Lower Thames Crossing

9.152 Responses to the Examining Authority's ExQ2 Appendix G – 11. Biodiversity (Part 1 of 2)

DATE: October 2023
DEADLINE: 6

Planning Inspectorate Scheme Ref: TR010032
Examination Document Ref: TR010032/EXAM/9.152

ExQ2_Q11.3.2 figures: Figure 1 - Woodland habitat loss mitigation (excluding ancient woodland impacts and compensation)

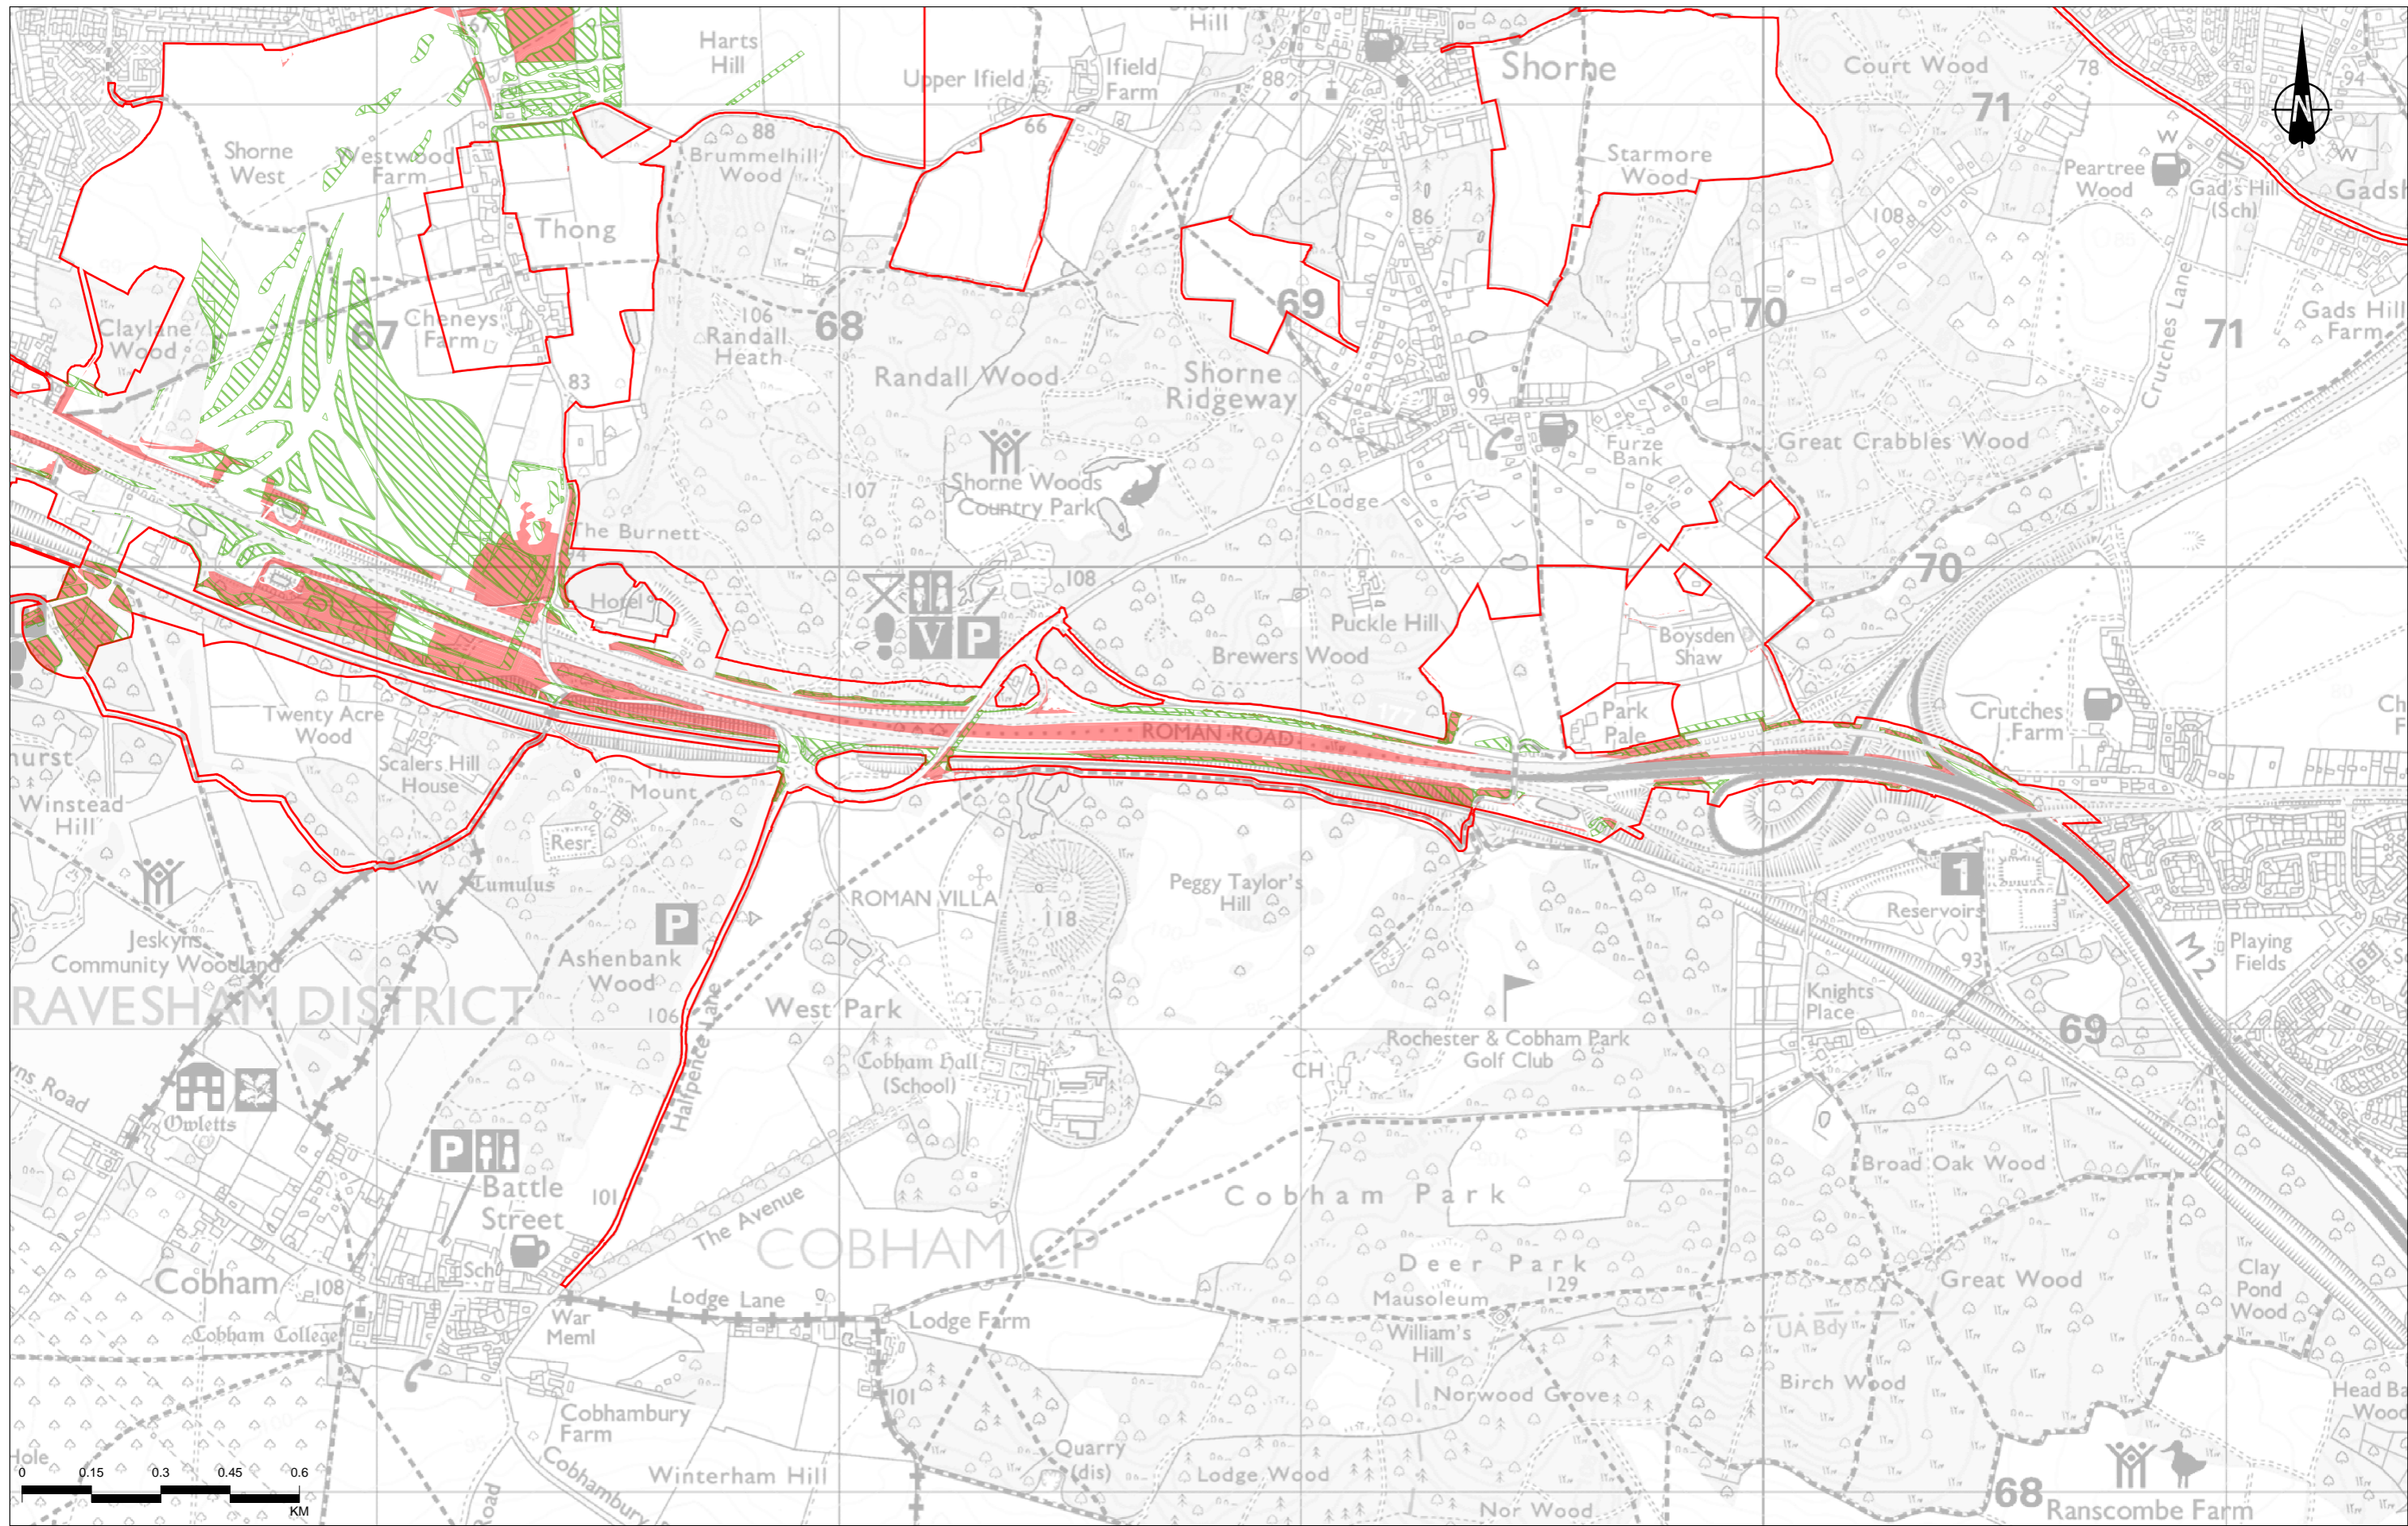
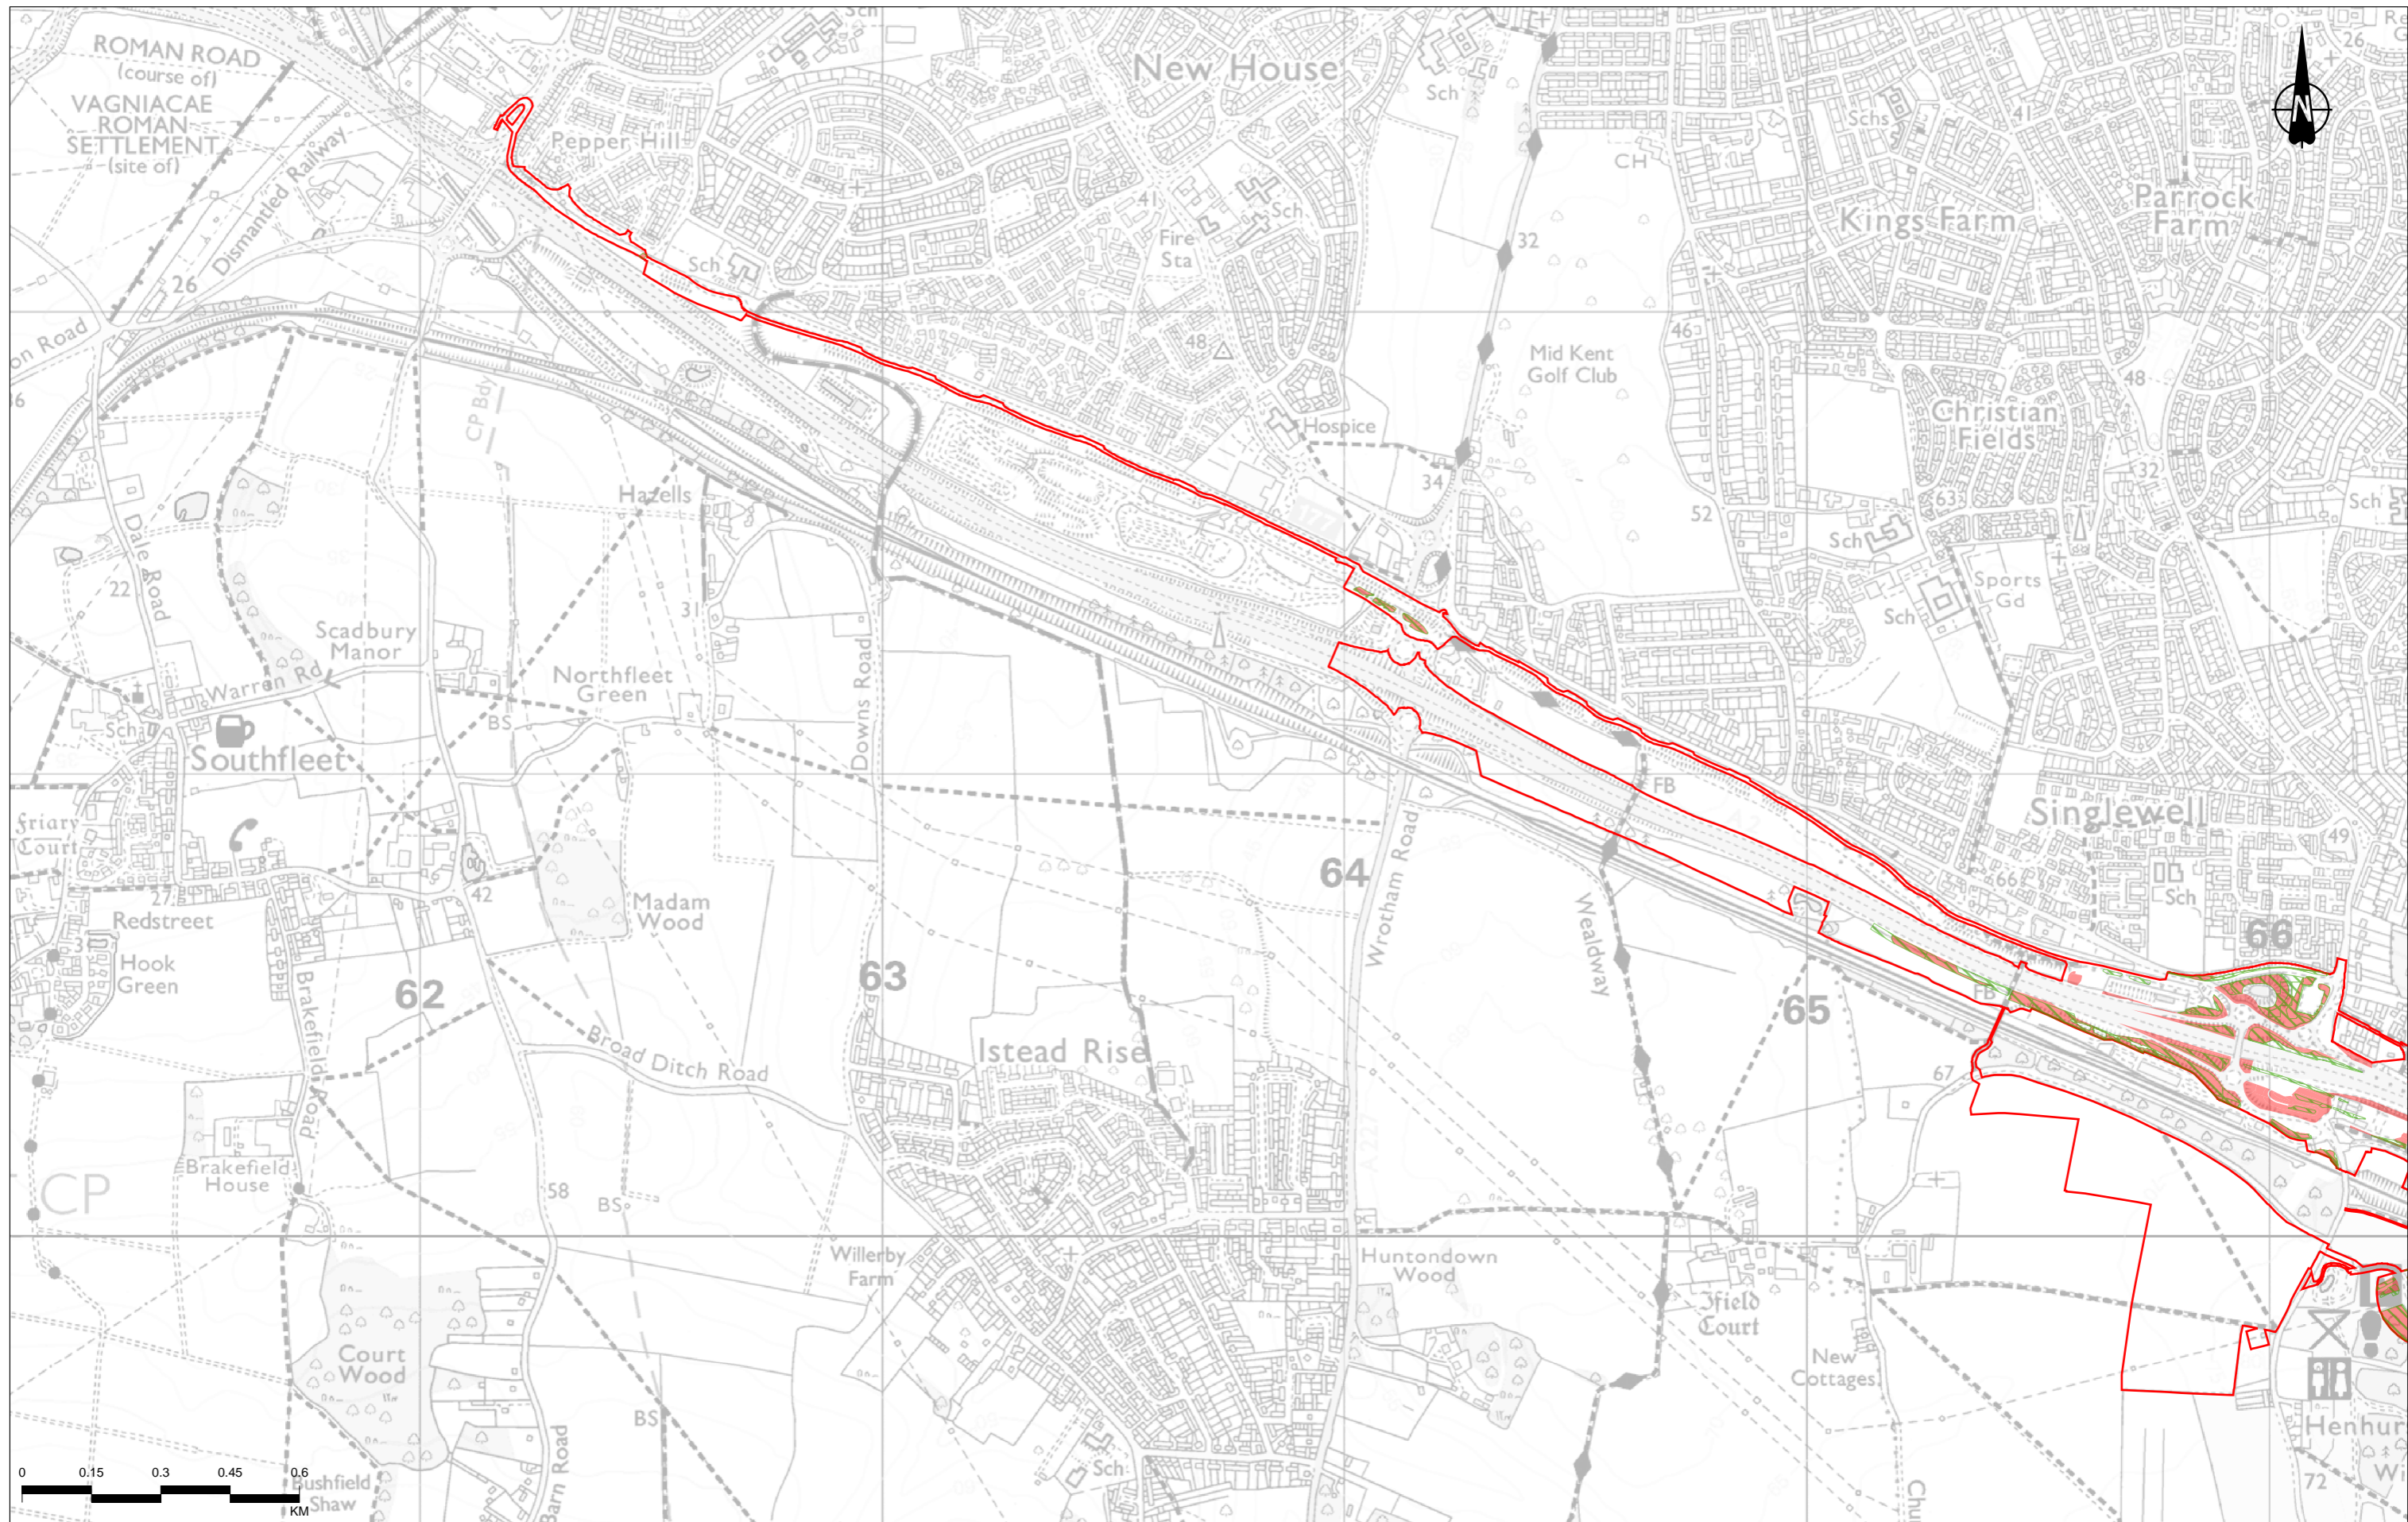
ExQ2_Q11.3.2	Applicant	<p>Offsetting</p> <p>The document reference 9.90 Mitigation Route Map [REP4-203] is noted, but the ExA would like to see a simple graphical representation / location plan to understand which area(s) of habitat are being created for particular impacts; such an approach will help provide clarity that the impacts are fully mitigated or compensated for. The detail provided in Tables 8.31 (south of the River Thames) and 8.35 (north of the River Thames) of Chapter 8 Terrestrial Biodiversity of the Environmental Statement [APP-146] are noted, but it continues to be difficult to track where the individual areas of habitat impacted are mitigated or compensated for on the ground within the submitted documents.</p> <p>Response:</p> <p>The Applicant has provided simple graphical representations which illustrate the location and extent of habitat creation proposals and the corresponding Project impacts for which they provide mitigation and compensation. These cover the following key habitat types:</p>

PINS ID	Question to:	Question / Response
		<ul style="list-style-type: none"> • Woodland (excluding designated woodland loss and compensation which is reported in ES – Figure 8.33: Ancient Woodland Impacts [APP-294]) • Open mosaic habitat • Grassland (excluding amenity and poor semi-improved grassland of low biodiversity value) • Hedgerows <p>These figures are provided in the Figures Annex to this document. We are also working to produce a similar map showing wetland habitats which, due to the range of wetland habitats involved, will be submitted at Deadline 7.</p>
ExQ2_Q11.3.3	Applicant	<p>Biodiversity Net Gain (BNG)</p> <p>In a similar manner to ExQ2 Q11.3.2 of this set of questions, the ExA requests the Applicant provide a graphical representation / location plan in addition to that detailed above showing all areas of environmental improvement included in the BNG metric.</p> <p>Response:</p> <p>The Applicant’s BNG Metric assessment [APP-417] includes all areas of <i>direct habitat loss and creation</i> within the Order Limits, with the following exceptions:</p> <ul style="list-style-type: none"> • Ancient woodland habitat lost (6.87ha) as a result of the Project is excluded from the baseline assessment. • Wood-pasture parkland habitat lost (0.07ha) as a result of the Project is excluded from the baseline assessment. • Bespoke compensation for ancient woodland loss (81ha) is excluded from the post-intervention assessment. • Nitrogen deposition compensation areas (246ha) are excluded from both the baseline and post-intervention parts of the assessment. <p>Areas of temporary land-take within the Order Limits are included in the BNG Metric assessment. For these areas, there is an assumption in the Metric assessment that the baseline habitat is lost and then re-instated post-construction to the same habitat type and condition as in the baseline.</p> <p>These explanatory notes support the Applicant’s submission of graphical representations / location plans which the Applicant commits to issuing by Deadline 7, so that it is clear which features on the plans are included in the BNG Metric.</p>
